# ADDENDUM TO THE ENVIRONMENTAL IMPACT ASSESSMENT

## GRAND PALLADIUM LADY HAMILTON RESORT & SPA AT POINT, HANOVER

Fiesta Hotel Group

**Document No.: ES\*PRJ 1004/04**

**FIGURE 1: PROPOSED ABSORPTION BED DESIGN**

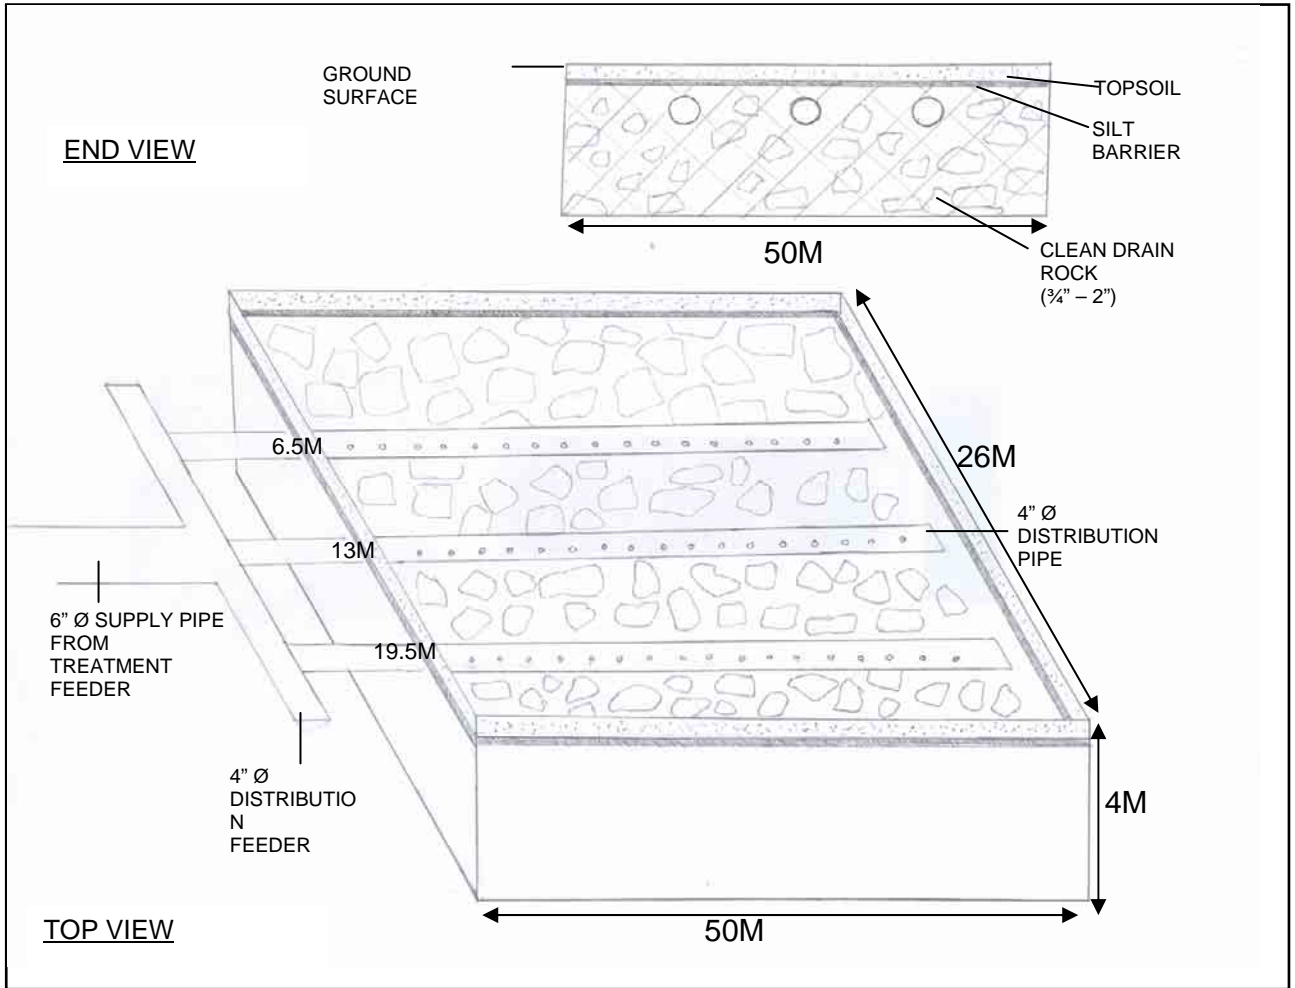
*2) Weather conditions (note Tropical Depression/ Hurricane Wilma for example) may prevent the use of effluent for disposal by irrigation. What are the alternative sewage disposal options in this event? What are the possible impacts and mitigations related to the alternative method/s*

Fiesta Hotels proposes to utilize an absorption bed disposal system for emergency disposal of treated effluent during periods of excessive rainfall. Rather than a series of trenches, one large bed will be utilized. This design is beneficial for this system for the following reasons:

Proposed absorption bed dimensions	50m long x 26m wide x 4m deep
Bed capacity without drain rock	5,200 m <sup>3</sup>
Bed capacity with drain rock (assuming 35% pore space reduction)	3,380. <sup>1</sup> m <sup>3</sup>
Maximum volume of wastewater possible (daily)	1,350 m <sup>3</sup>

The following basic installation process will be utilized in constructing the bed (see Figure 1 below):

- It is proposed that the bed will be excavated using a backhoe or similar equipment. If compaction or smearing is observed on the walls or bottom of the excavation, they will be raked to a minimum of depth of 25mm (one inch) before the clean drain rock is placed.

- The excavated bed will be filled from bottom to within approximately 600mm (24 inches) of ground level with clean drain rock ranging from 19mm (¾ inch) to 50mm (2 inches) in diameter.

- Perforated pipe of at least 100mm (4 inches) in diameter will be placed horizontally on this bed of rock with holes pointing down. Drain holes will be in double rows of 6-13mm diameter (¼ - ½ inch) located at approximately 150mm (6inch) intervals. Ends of the pipes will be capped.

- An additional 150mm (6 inches) of drain rock will be placed carefully on top of the pipes.
- Four (4) breather pipes of 100mm (4 inch) diameter will be placed vertically in the bed (two at each end) to allow for venting of the bed.

- A silt barrier (porous geotextile material) will be placed atop the drain rock to support the backfill material and minimize the potential for silting of the drain rock.

- 450mm (18 inches) of backfill material (native soil) will be placed on top of the silt barrier, compacted and landscaped to fit into the existing décor of the site.

**FIGURE 2: BEACH AND SAND DEPOSIT LOCATION FOR THE PROPOSED RESORT DEVELOPMENT AT POINT, HANOVER**

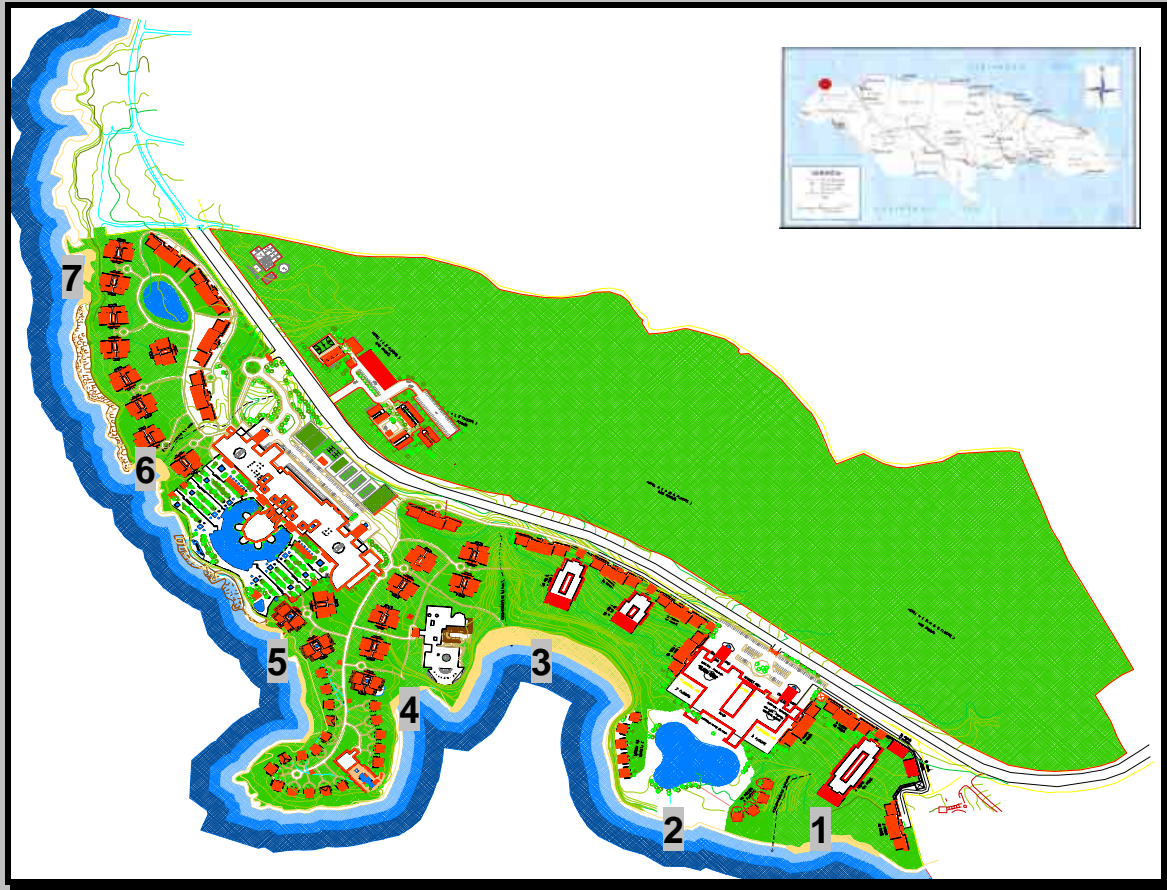
1. *Where, if any, are the beaches that will require modifications?*
  2. *What types of materials will have to be moved from the beach area and where are these areas located?*

3. *Where, if any, will seagrasses be removed from and relocated to?*
  4. *How much seagrass will be removed/relocated?*
  5. *Where, if needed, will replacement sand be sourced?*

The beaches that may require modifications are outlined in Figure 2 below.

The type of material to be moved from the beach area include; rubble on sandy shoreline and in shallow water that is in no way living material, washed up debris similar to that found along a typical beach front in Jamaica and sea grasses to provide appropriate bathing access

If necessary, sea grasses will be removed from beaches 3, 4, 5, 6, and 7 in Figure 2 above. The sea grass will be relocated to areas to the western and eastern boundaries of the shore front where sea grasses already exist.

The quantity of sea grass to be removed/relocated is unknown at this time, however the beach permit application will provide all the details.

It is not anticipated at this time that any replacement sand will be required at this site. The quality and quantity of sand available at the site appears to be sufficient.
